postal 16 17th Avenue, Voëlklip, Hermanus, 7200
physical 16 17th Avenue, Voëlklip, Hermanus, 7200
website www.capenature.co.za
enquiries Rhett Smart
telephone 087 087 8017
email rsmart@capenature.co.za
reference LS14/2/6/1/7/2/1486_residential_Vermont
date 6 November 2025

Amended Site Development Layout for the Proposed Residential Development on Erf 1486, Vermont, Hermanus (DEA&DP ref no 16/3/3/1/E2/40/1046/25)

Figure 1. Revised site development plan (Revision 24) presented to CapeNature following our comments submitted on 28 October 2025 wherein the residential erven avoid the delineated wetland and to which CapeNature does not object.

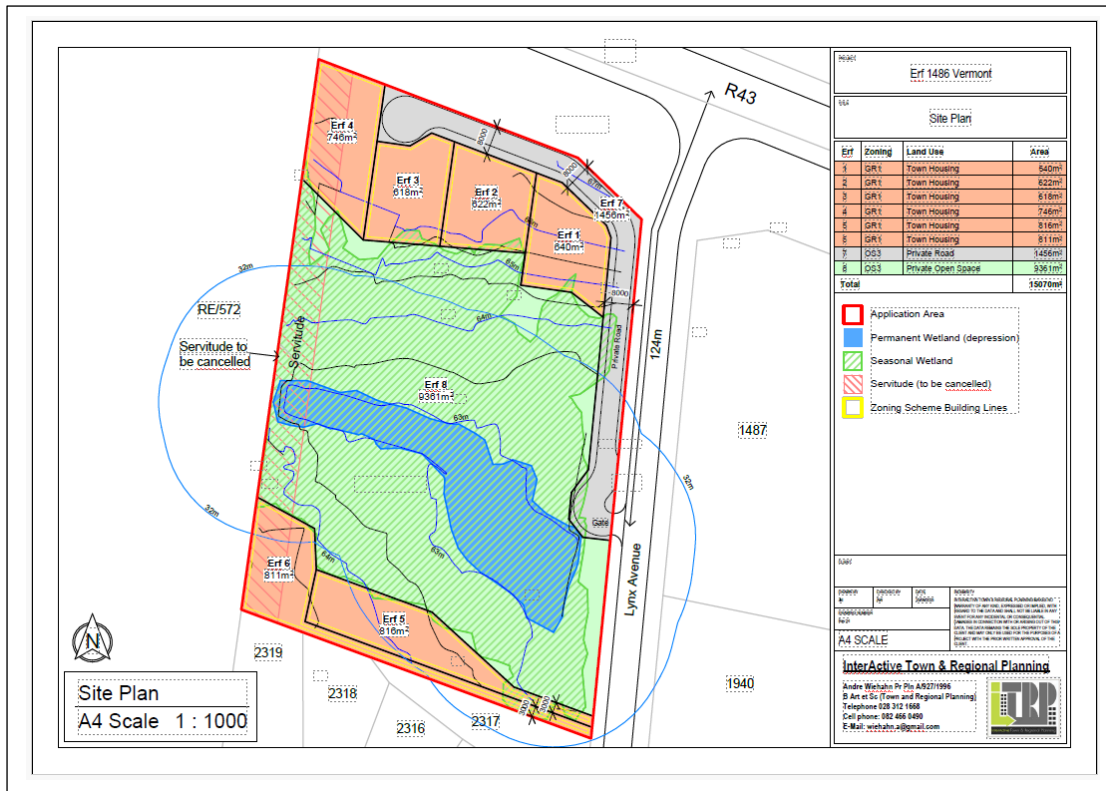
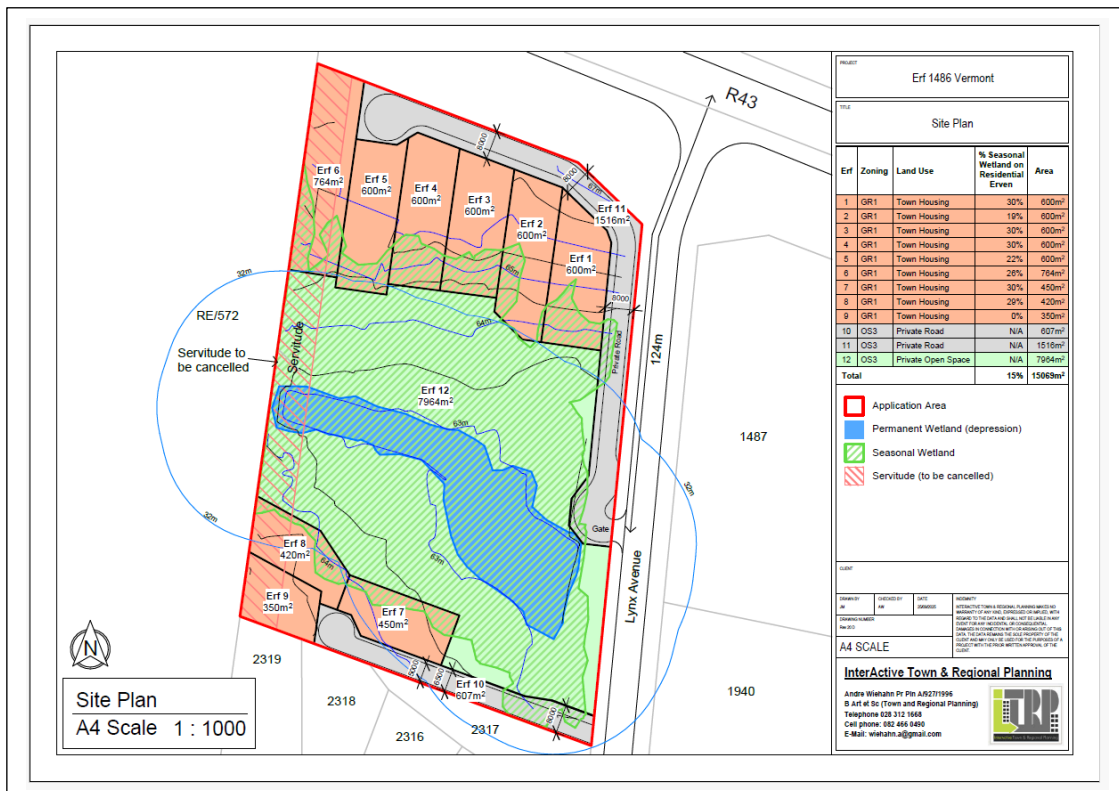
The primary outstanding concern regarding the application after four rounds of public participation is the encroachment of the residential erven into the delineated wetland as indicated in our most recent comments dated 28 October 2025. A motivation was provided that there are restrictions regarding the minimum size of erven within the suburb of Vermont.

Subsequently the applicant has provided a revised layout plan whereby the residential erven avoid the delineated wetland. There are very small linear encroachments which are unavoidable and for all intents and purposes and considering the motivation provided in the wetland delineation review regarding the wetland delineation, the current layout avoids the residential erven encroaching on the wetland. CapeNature is therefore satisfied that our concern has been addressed.

For record purposes, the current layout which we do not object to is indicated as Revision 24 and dated 25 September 2025 as indicated in Figure 1 below, whereas the layout presented in the most recent round of public participation (Final Basic Assessment Report) where there was encroachment into the wetland is indicated as Revision 20D and also dated 25 September 2025 and indicated as Figure 2 below.

Figure 2. Site development plan (Revision 20D) presented in the Final Basic Assessment Report as Appendix B3 wherein the residential erven encroach into the delineated wetland, and which is not supported by CapeNature.

In conclusion, CapeNature is satisfied that the concerns regarding the encroachment of the residential erven into the wetland have been addressed and we do not object to the current layout (Revision 24) subject to all other comments made in the four rounds of public participation.
